RE: Project Approval MP 10_0168 – Stage 1 building at Site 43/44 – 6 Australia Avenue, Sydney Olympic Park – Planning Statement in support of Section 75W Modification

This letter comprises a Planning Statement in support of a Section 75W Modification (s75W) to Project Approval (MP 10_0168) for the mixed commercial and retail development at 6 Australia Avenue, Sydney Olympic Park made on behalf of Capital Corporation. The proposed development (known as the Stage 1 building) was approved by a delegate of the Minister for Planning and Infrastructure under the former Part 3A provisions of the *Environmental Planning and Assessment Act 1979* (EP&A Act) on 31 July 2012. Changes are proposed to the scope of development which warrants the preparation of this s75W to modify the Project Approval.

Figure 2: Areas excluded from scope of Section 75W Modification and State Significant Developments

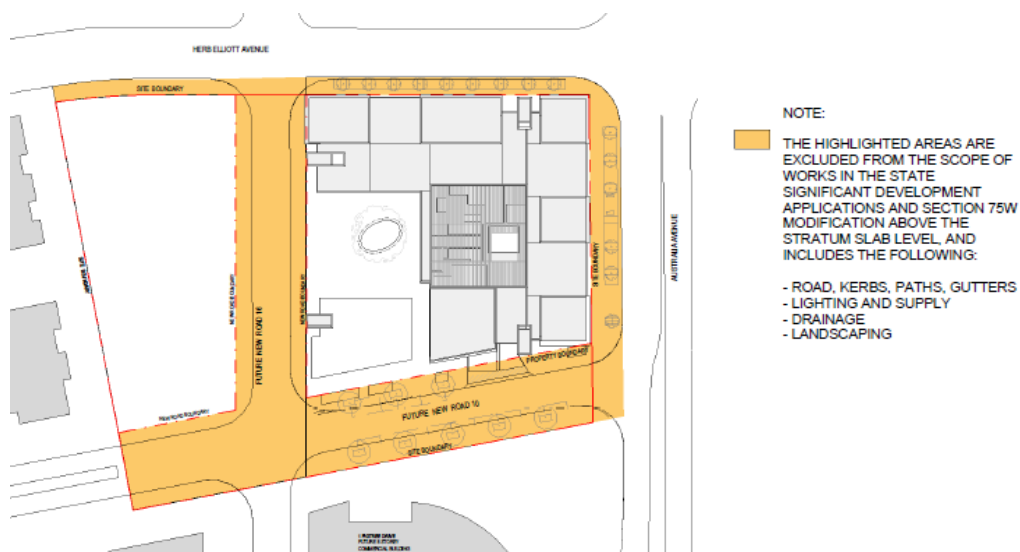
Note a key change between the Project Approval and this Section 75W is that the works within the road reserve do not form part of this application. The civil road design and the landscaping of the road verge areas are subject to SOPA designs. This is illustrated in **Figure 2** below.

Figure 3: Site Plan – Section 75W

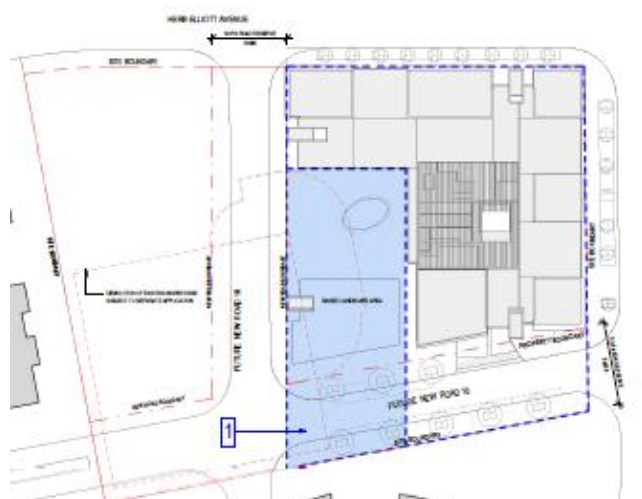
Another key change is that the extent of proposed works has both expanded and been reduced in this s75W. This is illustrated at **Figure 3** further below, and is described below:

- Extends to future New Road 16 to the west at ground level and the two basement levels;
- Reduced at the southern boundary to extend to the boundary with New Road 10 at ground level and reduced extent at basement levels to just extend over road boundary under future New Road 10;
- The extent of works to the eastern and northern boundary end at the boundary to the road reserve;

This shows the area of extent of works for the Section 75W Modification. The area shaded in blue relates to the expansion of the basement carpark compared with the Project Application, to accommodate 55 new car spaces for allocation to the Stage 1A Building.
